DART AEROSPACE LTD		Work Order: 77416
Description: Crosstube Assembly (205/212/412 High Fwd)		Part Number: D212-664-141
Inspection Dwg: D212-664-141 Rev: D		Page 1 of 1

DART AEROSPACE LTD HAWKESBURY, ONTARIO, CANADA	
DRAWING NO. D212-664-141	REV. D SHEET 1 OF 4
TITLE XTUBE ASS'Y (205/212/412 HI FWD)	SCALE NTS
COPYRIGHT © 2005 BY DART AEROSPACE LTD THIS DOCUMENT IS PRIVATE AND CONFIDENTIAL AND IS SUPPLIED ON THE EXPRESS CONDITION THAT IT IS NOT TO BE USED FOR ANY PURPOSE OR COPIED OR COMMUNICATED TO ANY OTHER PERSON WITHOUT WRITTEN PERMISSION FROM DART AEROSPACE LTD.

DRAWING NO. D212-664-141	TITLE XTUBE ASSY (205/212/412 HI FWD)	REV. D	DART AEROSPACE LTD ENGINEERING ORDER		D.E.O. NO. D212-664-141-D-1	SHEET NO. SHEET 1 OF 2	SCALE NTS
DRAWN	CHECKED	UP	MFG. APPR.	APPROVED	DE APPR.		
DATE 11.04.07	DATE 11.04.11		DATE 11.04.12	DATE 11/04/12	DATE 11.04.12

DRAWING NO. D212-664-141	TITLE CROSSTUBE ASS'Y (205 HI FWD)	REV. D	DART AEROSPACE LTD ENGINEERING ORDER		D.E.O. NO. D212-664-141-D-2	SHEET NO. SHEET 1 OF 1	SCALE NTS
DRAWN <i>UP</i>	CHECKED <i>ADS</i>	MFG. APPR. <i>DS</i>	APPROVED <i>MP</i>	DE APPR. <i>TH</i>			
DATE 11.07.15	DATE 11.07.20	DATE 11.07.21	DATE 11/07/21	DATE 11.07.21

**D212-664-141/-141B
ASSEMBLY DETAIL**

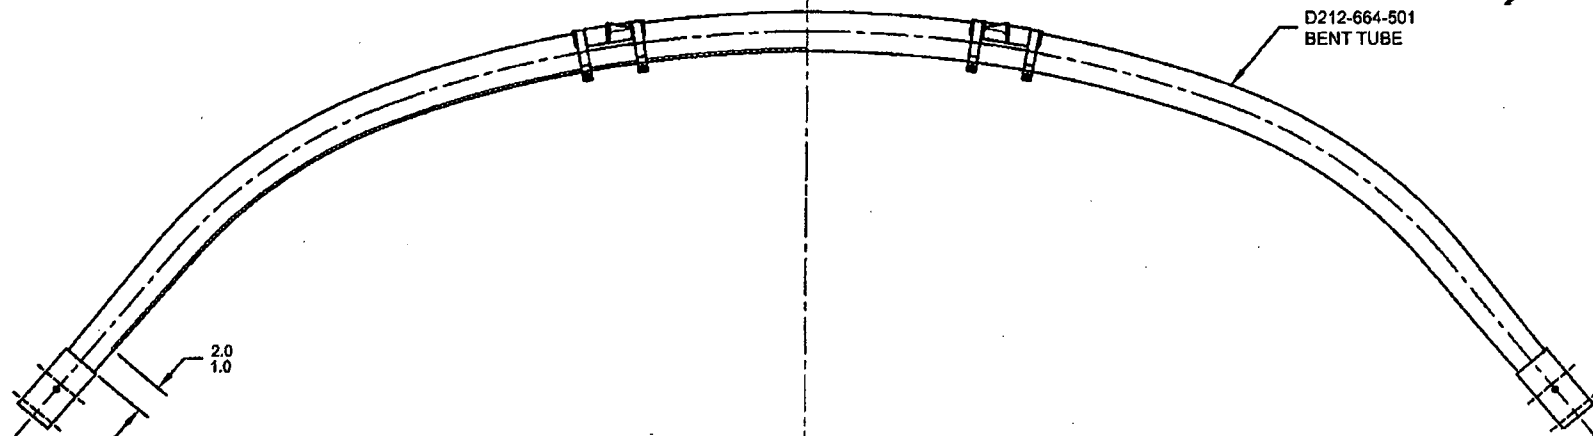
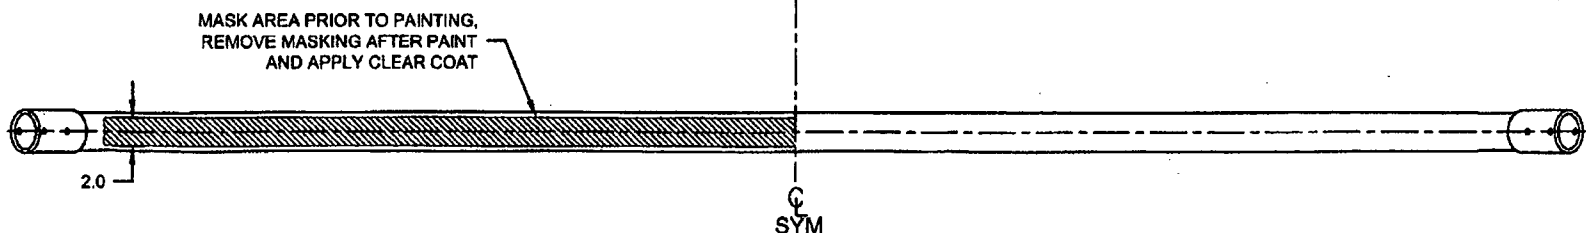
ADD AN INSPECTION WINDOW TO UNDERSIDE OF CROSSTUBE.

NOTES 2 OF SHEET 1 IS AMENDED AS FOLLOWS:

- 2) FINISH: CHEMICAL CONVERSION COAT PER DART QSI 005 4.1
PRIME INSIDE AND OUTSIDE PER DART QSI 005 4.2
MASK UNDERSIDE OF CROSSTUBE AS SHOWN (HATCHED AREA) AND
PAINT OUTSIDE PER DART QSI 005 4.2
REMOVE MASKING AND APPLY CLEAR COAT
